SUB-COMMITTEE ON STABILITY AND
LOAD LINES AND ON FISHING
VESSELS SAFETY - 29th session

IMPLEMENTATION AND INTERPRETATION OF
THE 1969 TONNAGE CONVENTION

Submitted by Japan

Report of the Ad Hoc Working Group

Figure 1

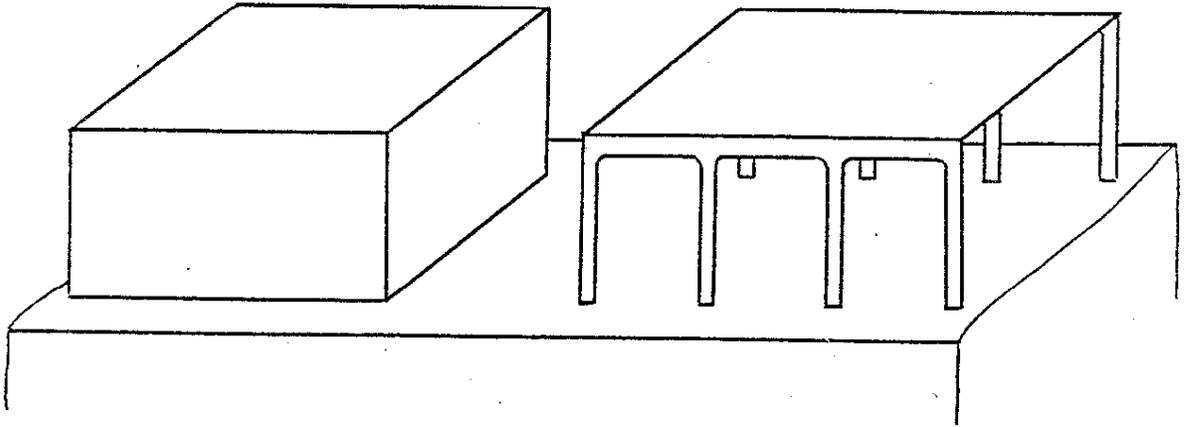
It is not clear whether the ends of an overhead deck covering are included in "the exposed sides" or not. According to Figure 7 in Appendix 1 of the Convention, it is understood that the ends of an overhead deck covering are included in "the exposed sides". Examples of a space under an overhead deck covering are shown in Figures 1-3, where drawing of bulwarks (or open rails) is omitted.

- .1 The space under the overhead deck covering as shown in Figure 1 is an excluded space.
- .2 The space under the overhead deck covering as shown in Figure 2 should not be an excluded space and treated as an enclosed space, because the overhead deck covering connects the deckhouse at its ends.
- .3 The space under the overhead deck covering as shown in Figure 3 should also be treated as an enclosed space.

- .1 the definitions in Regulation 2(5)(b) do not restrict consideration only to erections extending from side to side of the ship;
- .2 "exposed sides" refer to longitudinal sides and not to the ends of the erections.

Referring to figures 1, 2, 3, these spaces in question should all be regarded as excluded spaces provided these spaces are not fitted for cargo or stores.

Figure 4

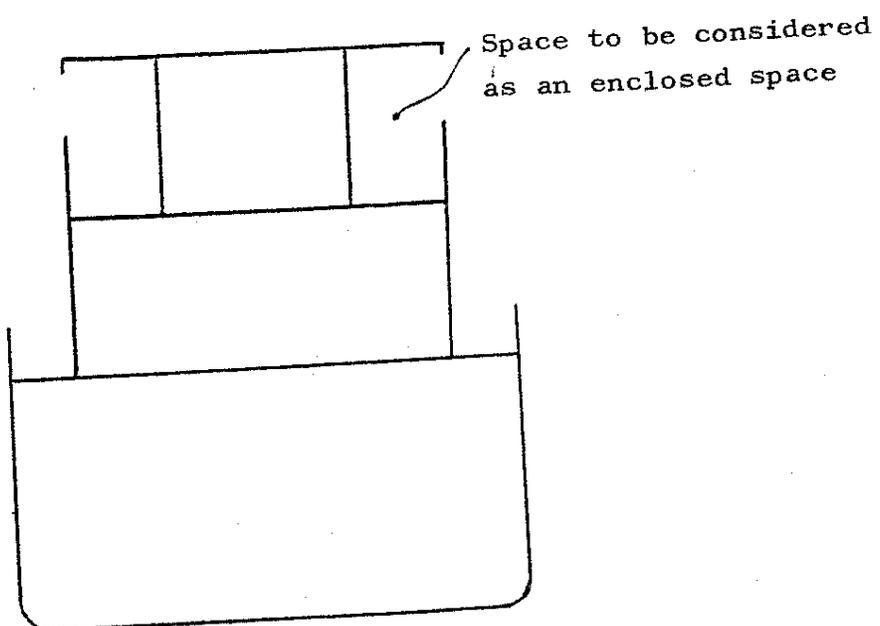
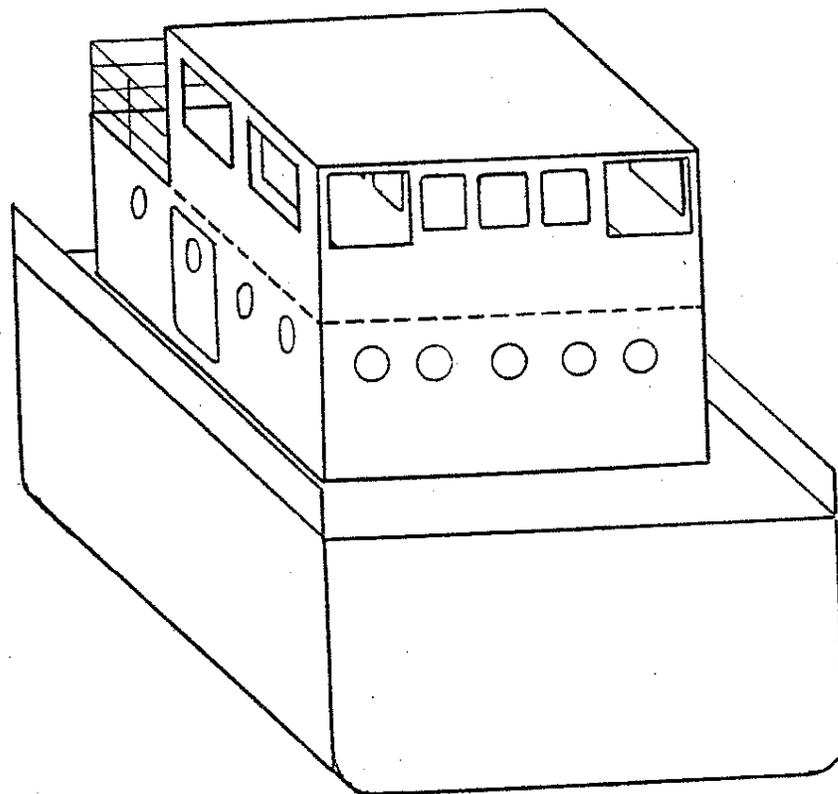
As the space shown in Figure 2 of Appendix 2 of TM.5/Circ.1 is a space in a side-to-side erection, it is excluded from enclosed spaces. The space as shown in Figure 4 of this paper is not the space in a side-to-side erection, so it should be treated as an enclosed space.

3.3 Referring to Fig. 4, the space concerned should be considered under Regulation 2(5)(b) instead of Regulation 2(5)(c) and should be regarded as excluded space.

Reference is made to the reasons quoted in 3.2.

Figure 5

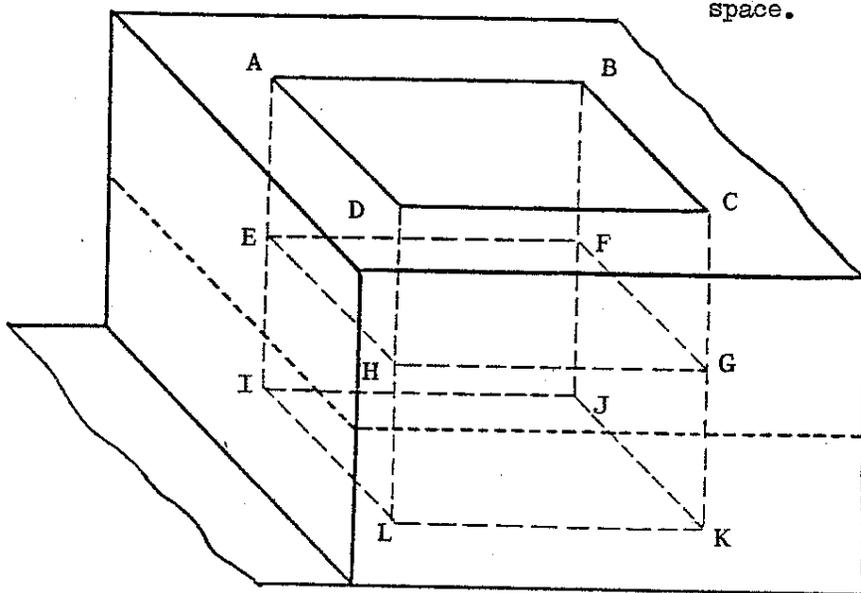
In the case of the erection which has two tiers of decks having openings, it is considered that a space in an erection immediately below an uncovered opening in the deck overhead is limited to the deck immediately below the exposed deck, so the space below the inner deck opening should be treated as an enclosed space (Figure 5).

Space EFGHIJKL is to be considered as an enclosed space.

According to the definitions in this Regulation there is no limit to the number of tiers of erections. For this reason the space shown in Fig. 5 lettered ABCDLIJK is to be considered as an excluded space, provided this space is not fitted for cargo or stores. The group considered that the lowest point of an open space, such as shown, should be the upper deck.
